UPDATED RESPONSES TO THE
U.S. NUCLEAR REGULATORY COMMISSION
REQUEST FOR ADDITIONAL INFORMATION
ON THE WEST VALLEY DEMONSTRATION PROJECT
PHASE 1 DECOMMISSIONING PLAN

RAIs 5C6, 5C7, 5C9, 5C10, 5C12, 5C15, and 5C21

November 6, 2009

U.S. Department of Energy
West Valley, New York

Figure 5C6-1 Recreationist Conceptual Model Cross Section

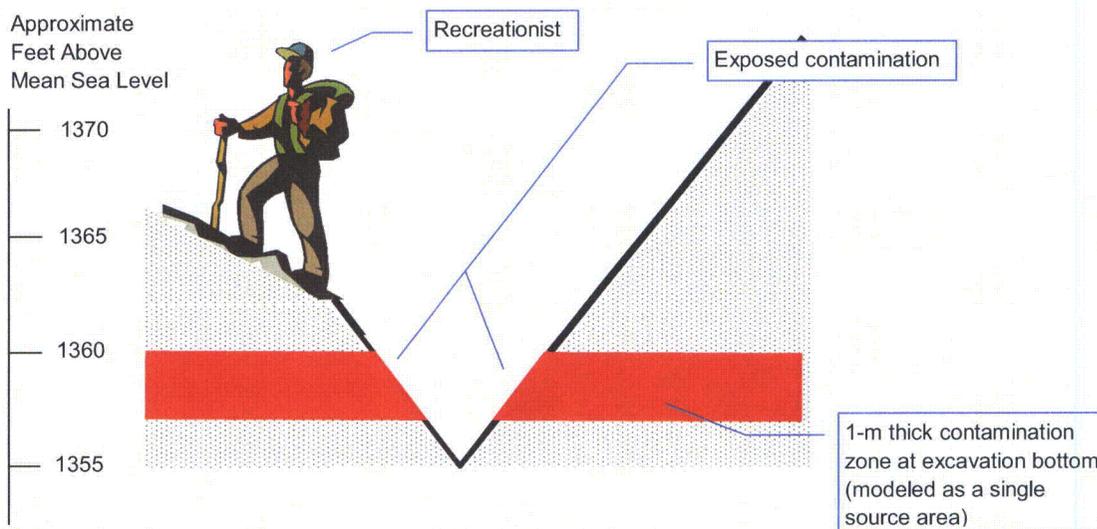
DOE acknowledges that gully erosion could intrude upon the lagoon areas (see page 5-14). However, DOE did not provide quantitative support for its assumption that erosion from gully formation/advancement, or stream widening could intercept the WMA 2 source areas and produce greater exposures to an offsite or onsite receptor.

Path Forward: DOE should provide the results of a quantitative analysis that supports its assumption that the subsurface DCGLs calculated assuming a cistern driller scenario bound the potential impacts from erosion.

A plausible scenario for these conditions would involve a recreationist spending time hiking in the area, which is assumed to be rent by deep gullies that extend to the bottom of the WMA 2 excavation. Figure 5C6-1 illustrates the basic conceptual model. This scenario was analyzed using RESRAD in the deterministic mode with the following key conceptual model input parameters:

- The exposed contamination zone area in the gully walls is assumed to be two meters wide and 100 meters long, a reasonable size to represent the likely geometry of the exposed contamination in the gully (modeling a single source area rather than the two illustrated in Figure 5C6-1 was more practical);

Figure 5C9-1. Pre-2007 Inferred Areal Extent of the Lavery Till Sand in the North Plateau

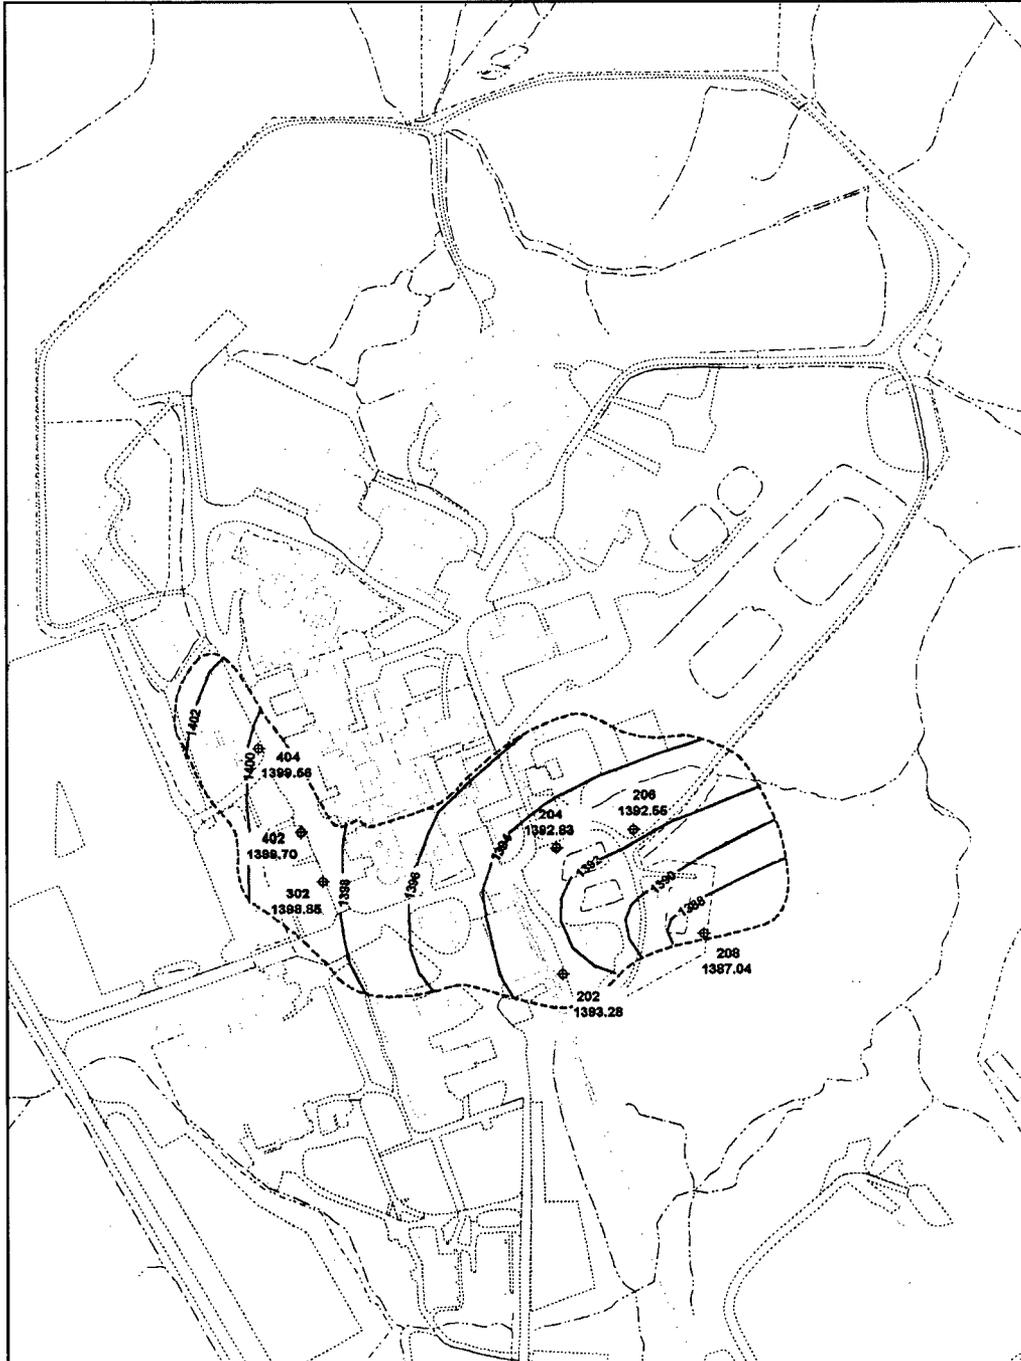
Additional information may be needed to support the hydrogeological conceptual model for contamination assumed to be present underneath WMA 1 and 2 used to derive subsurface DCGLs. Previous geologic interpretations showed contamination of a significant portion of the Lavery Till and Lavery Till Sand underneath the Main Plant Process building that could lead to pathways of exposure not considered in the current analysis. DOE should indicate how it plans to manage the risk associated with significantly greater contamination levels at depth along H-piles or within the Lavery Till then were assumed in the DCGL calculations.

Path Forward: DOE could provide additional information such as borehole logs for those locations where the top of the Lavery Till was significantly lowered and the Lavery Till Sand eliminated underneath the process building in the vicinity of the source of the North Plateau groundwater plume. Additional cross-sections overlaying recent concentration data over reinterpreted geology underneath the process building would also provide additional confidence in the revised hydrogeological conceptual model.

The Lavery till sand is not located beneath the Process Building nor within the north plateau groundwater plume and previous interpretations of the extent of this unit have not suggested its location beneath the Process Building. Re-examination of borehole logs from the north plateau in 2007 resulted in a re-evaluation of the areal extent of the Lavery till sand. Copies of the borehole logs that were used to revise the extent of the Lavery till sand are attached. Table 5C9-1 (which appears at the end of the text) summarizes the revisions to the geologic interpretation of the boring logs used to delineate the extent of the Lavery till sand as described in Figure 3-64 of the DP.

From 1991 to 2007 the Lavery till sand was inferred to be present to the west, south, and southeast of the Process Building in a location that was hydraulically upgradient and cross-gradient to the north plateau groundwater plume (Figure 5C9-1). Earlier interpretations of the borehole logs considered a prominent clay-rich geologic horizon up to several feet in thickness as part of the unweathered Lavery till and the underlying sandy unit as the Lavery till sand.

Figure 5-10. Modified Conceptual Model for Subsurface Soil DCGL Development

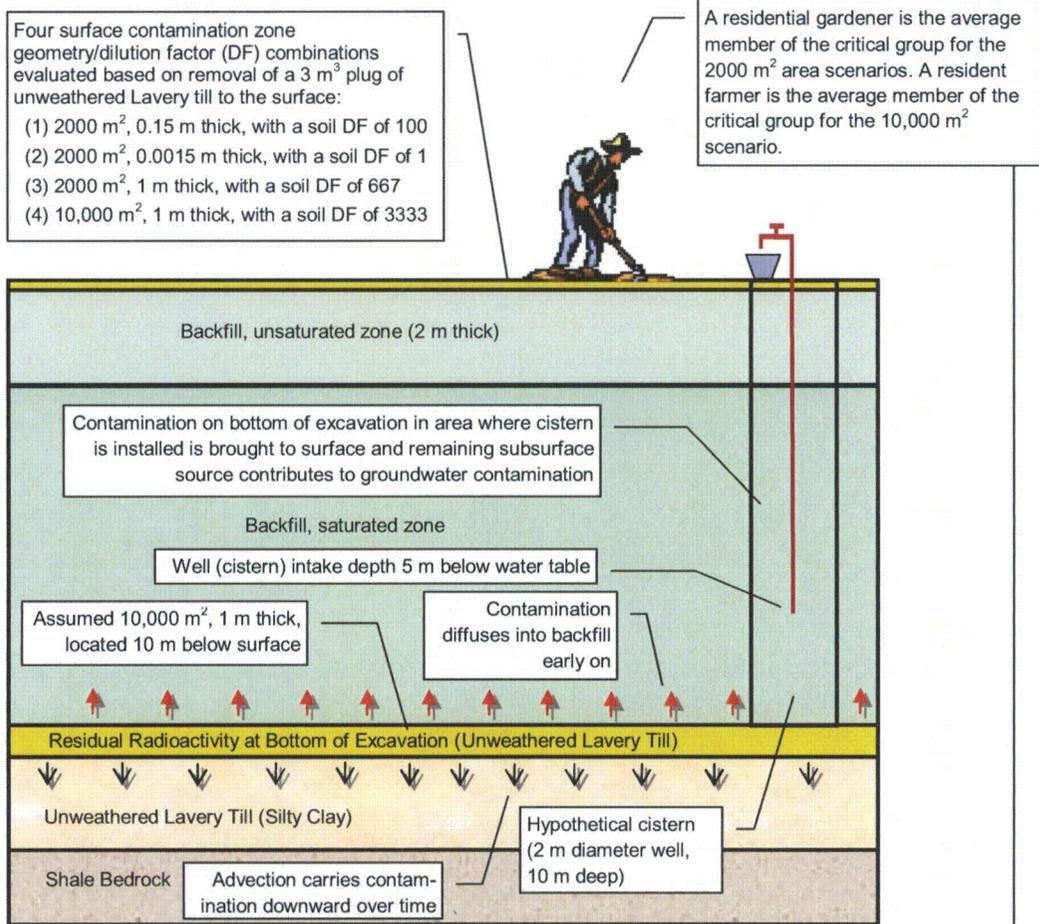
RAI: DOE has not provided sufficient information to justify lack of consideration of subsurface contamination at the bottom of WMA 1 and 2 excavations when deriving subsurface soil DCGLs. Additional data collected on the extent of Lavery Till contamination as remediation proceeds may show greater extent of contamination than originally assumed, additional transport pathways not considered in the subsurface DCGL calculations (e.g., contamination of Lavery Till Sand or along H-piles in the Lavery Till), or greater accessibility of contamination at depth than what is expected. (Section 5.2.1, Page 5-23)

DOE should clarify how the residual risk from contaminated soil located just below 1 m (e.g., on the sides of the excavations) is appropriately accounted for when comparing residual concentrations to subsurface DCGLs which assume the contamination is mixed with clean soil at a ratio of one to ten (i.e., dilution factor of ten). DOE indicates in a footnote on page 5-4 that contamination on the sides of the excavation up- and cross-gradient from the source area is not

As noted in Section 5.2.1, the original base-case conceptual model used in developing the subsurface soil DCGLs recognizes one source of contamination – the Lavery till from the bottom of one of the deep excavations that is brought to the surface during construction of the hypothetical cistern. This model does not consider potential impacts to groundwater in the backfilled excavation from continuing release of remaining residual radioactivity at the bottom of the deep excavations.

To address this limitation, analyses were performed that take into account the impacts of releases of this other residual radioactivity on both a hypothetical residential gardener and a resident farmer with a modified model that accounts for a surface and a subsurface source of radiation. Figure 5-10 illustrates the modified conceptual model used in these analyses.

The excavation bottom is treated as two distinct sources: (1) a plug of contaminated soil from the excavation bottom that is brought to the surface during installation of the cistern and spread over the entire surface of the hypothetical garden, and (2) the remaining contaminated Lavery till at the excavation bottom from which residual radioactivity moves upward by diffusion and enters groundwater being drawn into the well. Both the residential gardener scenario and the resident farmer scenario were considered as indicated in Figure 5-10.
